BLDG. PERMIT STOPPED
AND RETURNED 4-18-61
BDD129178

B00129178 - garage/2 story addition

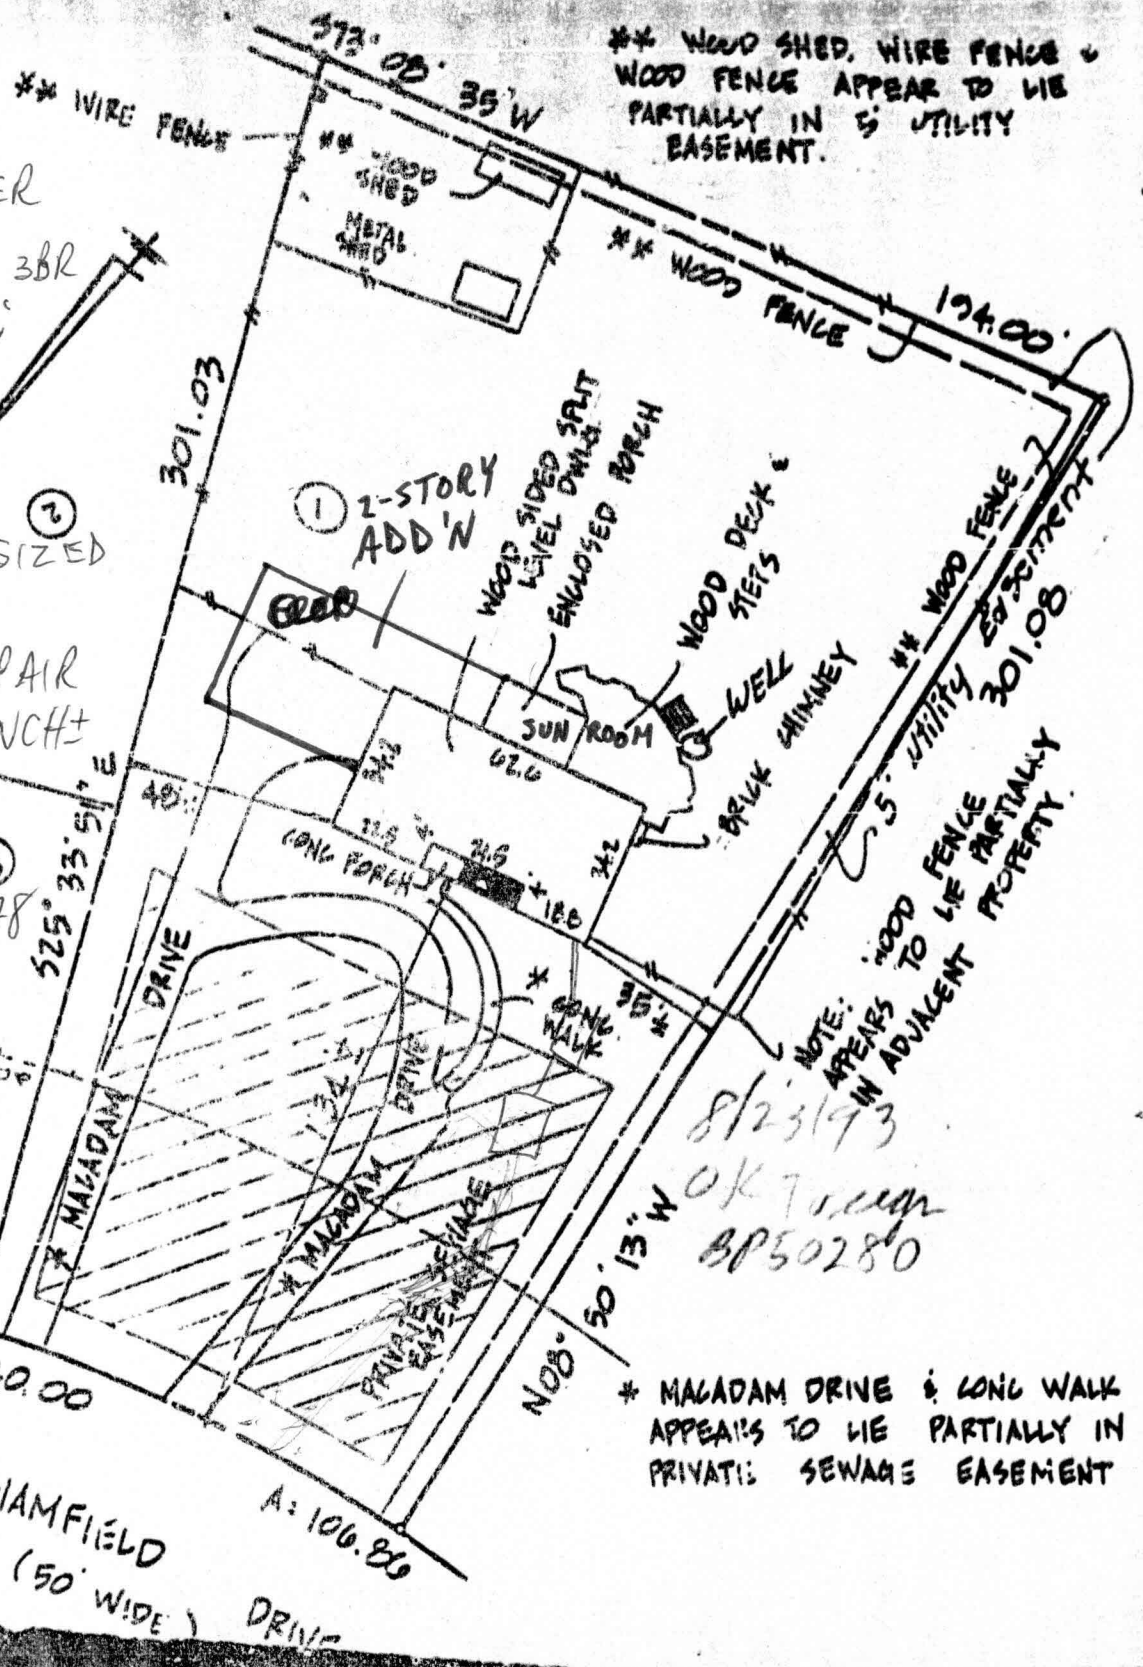
EX. HOUSE 3BR
NOT 4BR;

2 BR
BEING

ADDED
EX. S.S. SIZED
FOR 4 BR

1 BR REPAIR
45' TRENCH+

OK
